Council Action and Executive Summary

TITLE: AN ORDINANCE APPROVING A CONCEPT PLAN FOR A PLANNED UNIT DEVELOPMENT (PUD) KNOWN AS THE GOOD SAMARITAN SOCIETY VILLAGE II. THE SUBJECT PROPERTY ENCOMPASSES 13.223 ± ACRES AND IS LOCATED ON THE SOUTHWEST CORNER OF NORTHRISE DRIVE AND ROADRUNNER PARKWAY; PARCEL ID# 02-41025. SUBMITTED BY QUANTUM ENGINEERING CONSULTANTS ON BEHALF OF THE EVANGELICAL LUTHERAN GOOD SAMARITAN SOCIETY, PROPERTY OWNER (PUD-10-06).

**Planning & Zoning
Commission
Staff Report**

PROJECT NAME: Good Samaritan Society Village II PUD (Planned Unit Development) Concept Plan

SITE CONCEPT PLAN TRACT B
SCALE: 1" = 100'

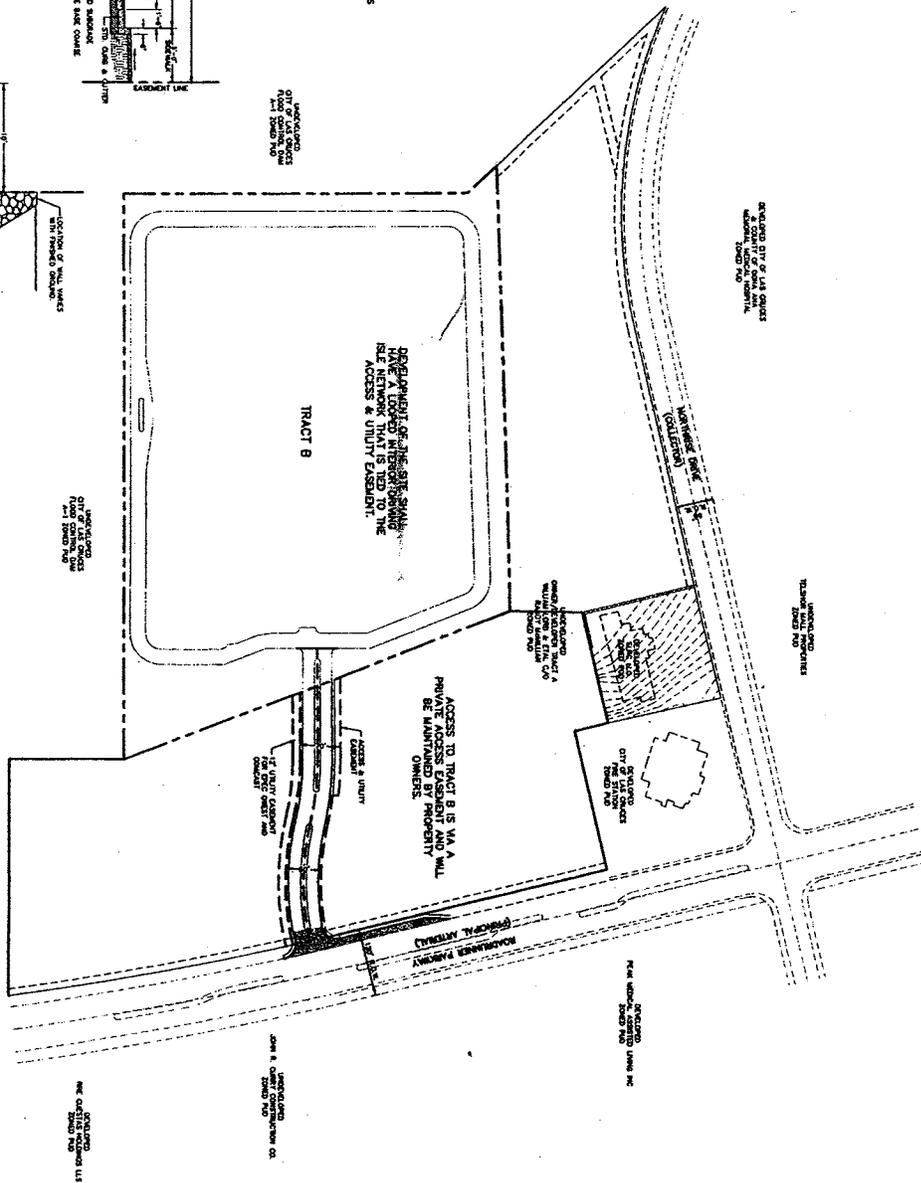
Our approval of the submitted documents also includes the preliminary approval of the PUD modifications including densities, use, mixed-use, setbacks, etc. **with the following exceptions:**

1. All references to future submittals for building permits (final structures and parking) and detailed subdivision / site designs shall include the NDC approvals. This includes Civil Engineering, AIA Architecture and Landscape Architecture. Submittals to the NDC shall be in accordance with our Design Standards and Guidelines.
2. On the McTimski Concept Plan, the references to future approvals by the CLC should be modified to include the NDC.

6. The provisions for a "green roof" does not replace the requirement for screening and materials for visible roofs or portions (barrel tile).
7. Our requirements that landscaping installation and warranties be under the purview of the building AIA or ASLA – through the warranty period, should be included.

8. The detailed provisions cited as PUD concept requirements do not replace the Northrise Business Park Standards and Guidelines. The more restrictive will apply.

Final approval for the purpose of a PUD amendment is implied, if the plans are modified as suggested by items 1-8, above.
